State of Washington
POLLUTION LIABILITY INSURANCE AGENCY
300 Desmond Drive SE • PO Box 40930 • Olympia, Washington 98504-0930
(360) 407-0520 • (800) 822-3905 • FAX (360) 407-0509
www.plia.wa.gov

Re: No Further Action at the Following Site:

- **Facility/Site Name:** Northwest Hardwoods Arlington
- **Facility/Site Address:** 20015 67th Avenue NE, Arlington, WA 98223
- **Facility Site ID:** 36489214
- **PTAP Project No.:** PNW252

PLIA has determined that **no further remedial action is necessary** to clean up contamination at the Site.

Figure 3: Western Parcel Detail Map

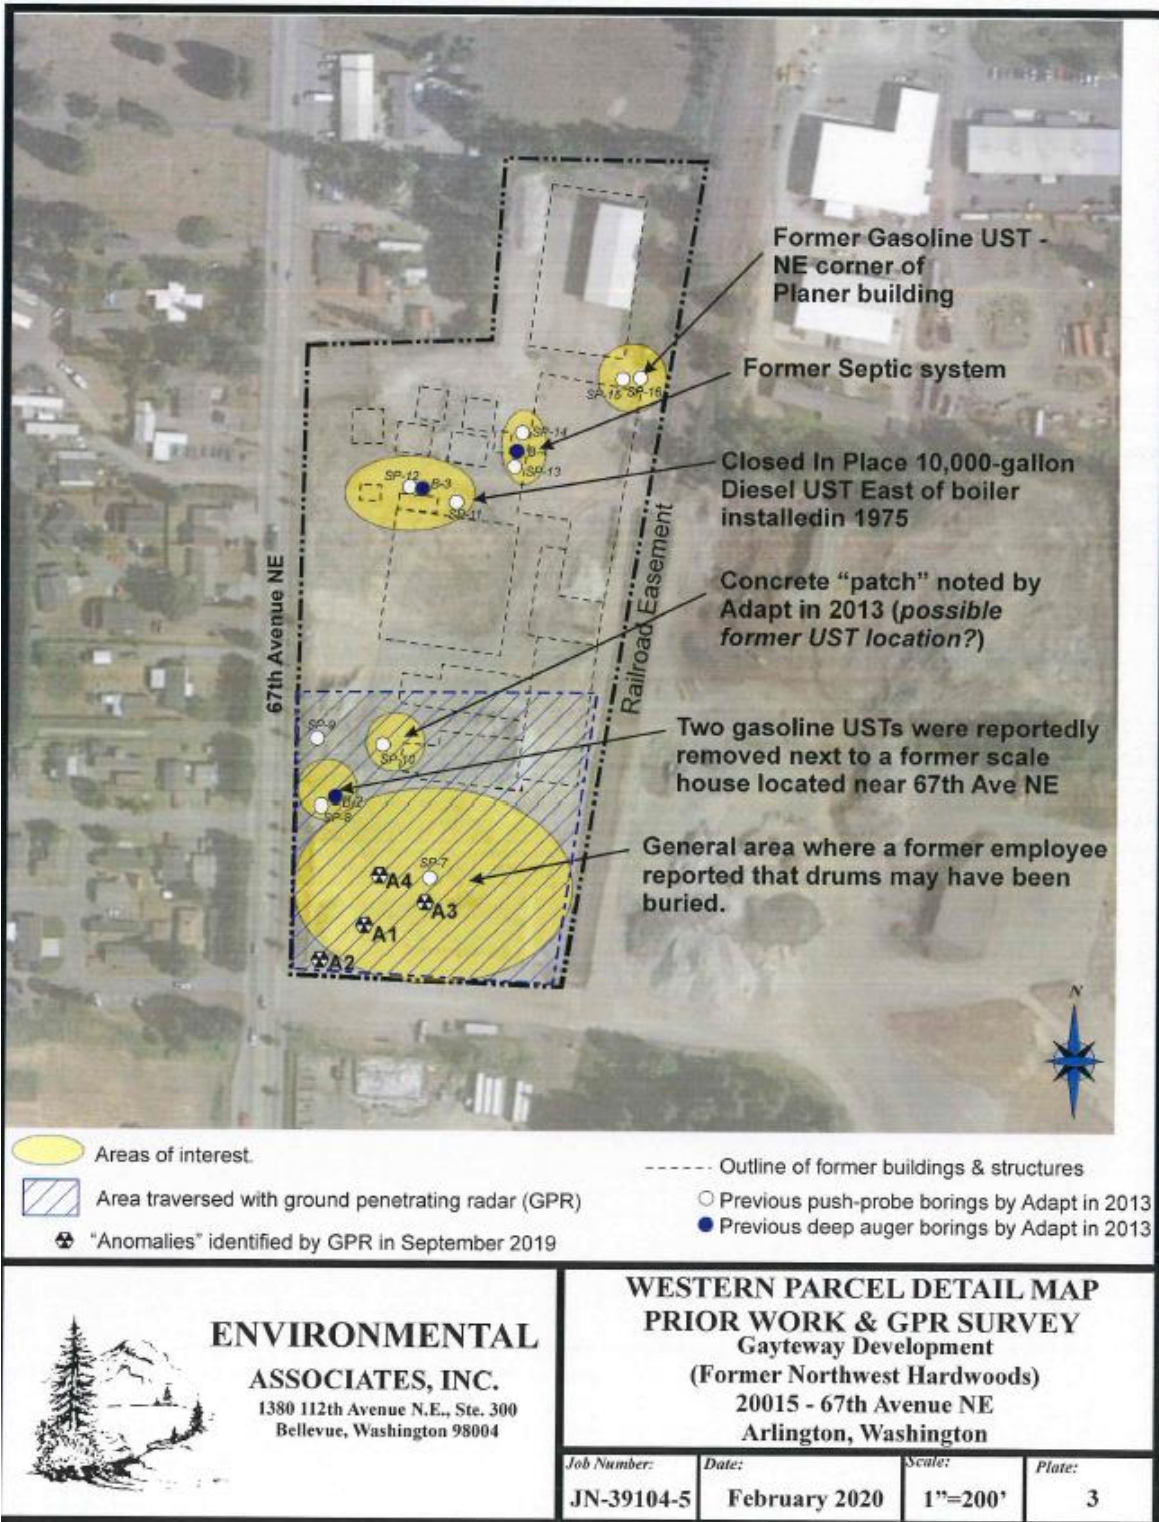
- i. **Soil Direct Contact Narrative:** PCS was identified at the southern end of the western portion above the MTCA Method A CUL in the vicinity of soil test pits SS1 and SS2 (Fig. 3, Table 1). Soil contamination was encountered at approximately 0-14' bgs within the depths (0 to 15' bgs) that humans (utility workers and property developers) may come in contact.

Figure 4: Western Parcel Excavation and Sampling Map

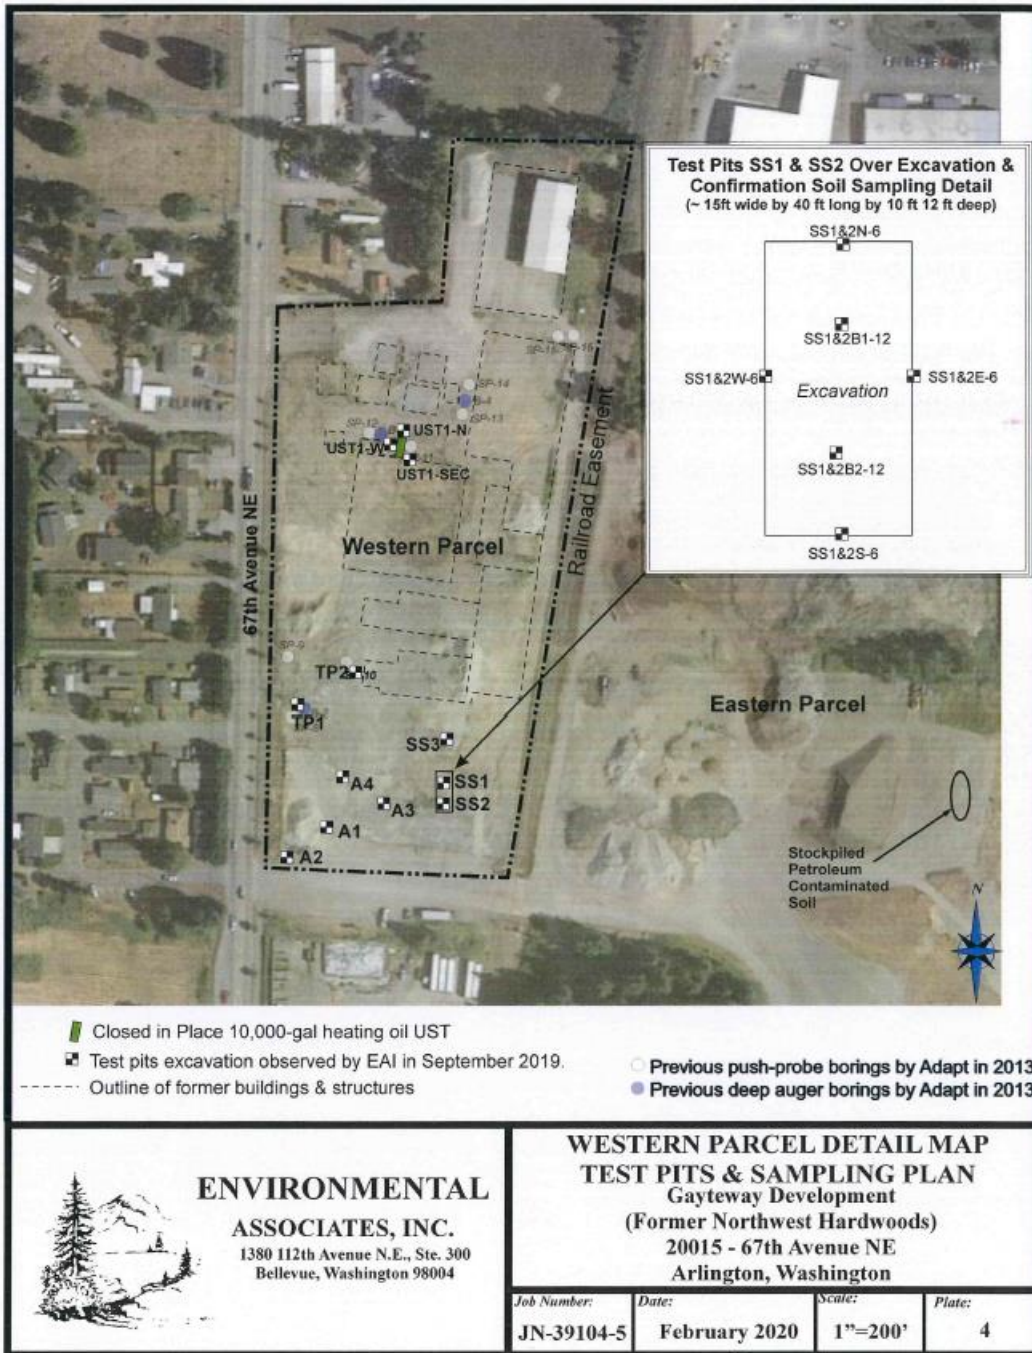
- **Soil Direct Contact Narrative (Post-Cleanup):** Interim remedial action completed in September 2019 included the excavation of an area approximately 15' wide by 40' long to a depth of 12' bgs. Approximately 648.85 tons of soil were removed during excavation and stockpiled on the eastern parcel and covered with a plastic sheet, soil was later removed to the Cadman Facility in Everett Washington. Post excavation soil confirmation samples indicated that all contaminants of concern were successfully excavated below the MTCA Method A CUL (Fig. 4, Table A6).

Result: The soil direct contact exposure pathway is no longer a concern at this Site.
